F.1.a.e 2727 Hamilton: Development Permit with Variances Application No. 00160 (Oaklands)

Subject: Development Permit with Variances Application No. 00160 for 2727 Hamilton

2727 Hamilton Rd Development Permit with Variance No. 00160

Figure 1:

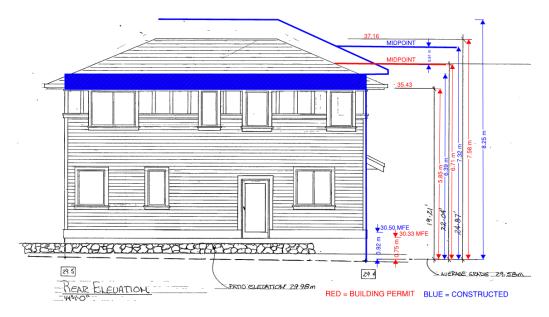
In the original application a front yard setback variance was approved which reduced the setback requirement from 6.0m to 3.14m. During construction, the height of the building was increased by 0.61m (from 6.71m to 7.32m), due to raising the elevation of the first floor, as well as, increasing the floor to ceiling height of the second storey. Although the proposed height of 7.32m is still below the maximum allowable height of the R1-S2 Zone, it "exacerbates" the reduced front yard setback relaxation by placing additional building mass within the reduced front yard setback.

While raising the building height does increase the prominence of the building as seen from the street, as well as increase potential shading impacts, the additional massing now located in the front setback area, does not have a significant impact on these considerations.

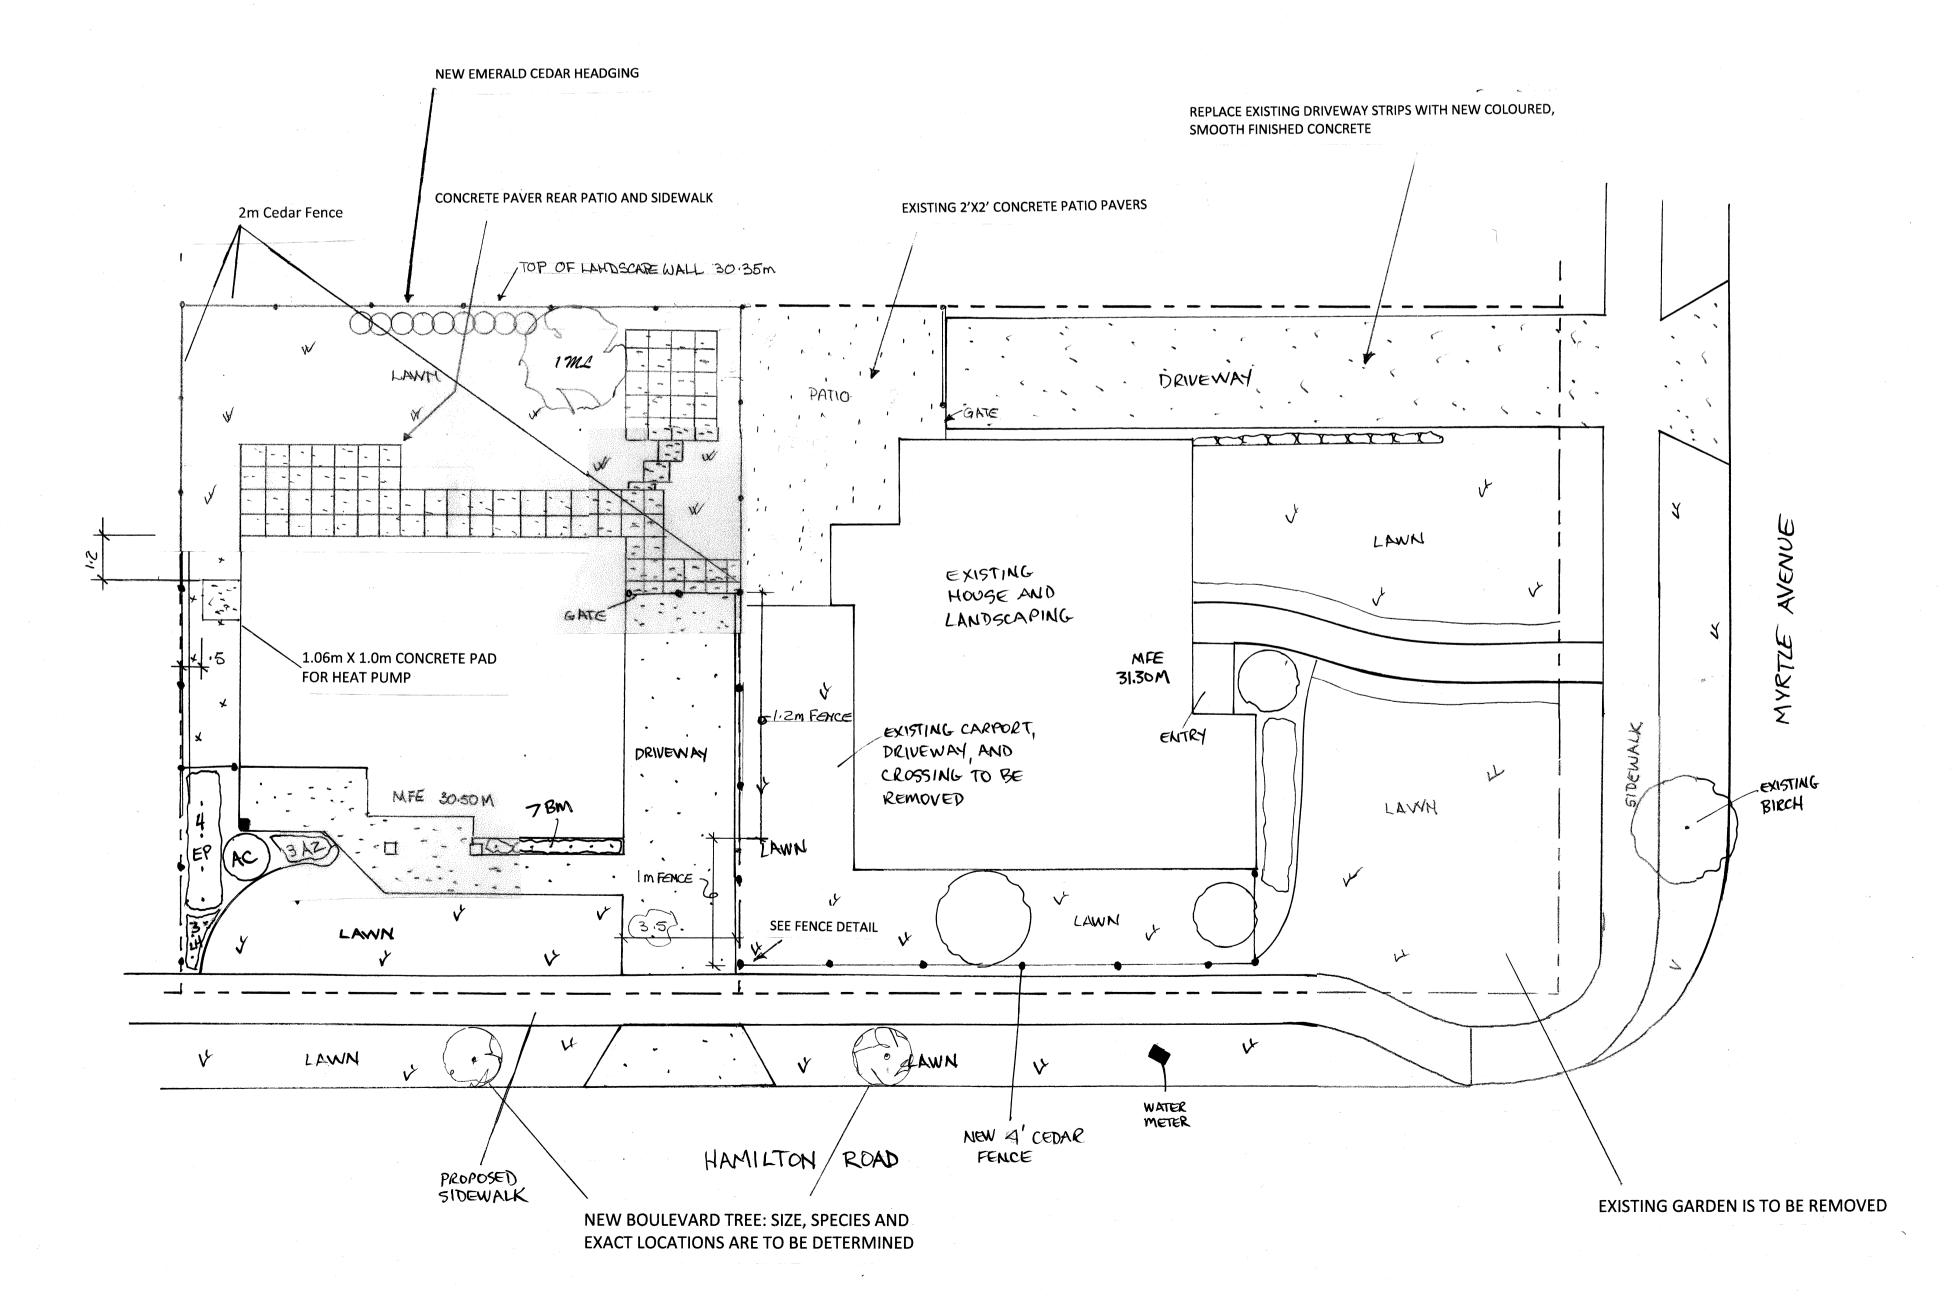
The R1-S2 Zone requires the north side yard setback to be a minimum of 1.50m; however, a heat pump was installed within this setback. Therefore, a variance is required to reduce the setback from 1.50m to 0.50m. The heat pump is located on the north side of the house, adjacent to a parking lot where it will have minimal impact on neighbours and would be screened by a 2.0m fence.

The small lot design guidelines encourage applicants to respect the existing topography and to avoid major changes to existing grades. During construction, a retaining wall was added around the sides and rear of the property ranging in height, from a few inches to approximately one meter near the rear of the property. This area was then filled, creating a grade change between the subject property and its neighbours. Although this change in grade does not trigger the need for a variance, it is not consistent with the design guidelines and could create potential privacy and visual impacts for the neighbouring properties. The applicant is proposing a new 2.0m cedar fence on top of the wall as well as, a row of emerald cedar hedges and a Magnolia tree to provide a landscape buffer. The addition of the fence and landscaping helps mitigate the impact of the increased grade; however, the change is inconsistent with the design guidelines.
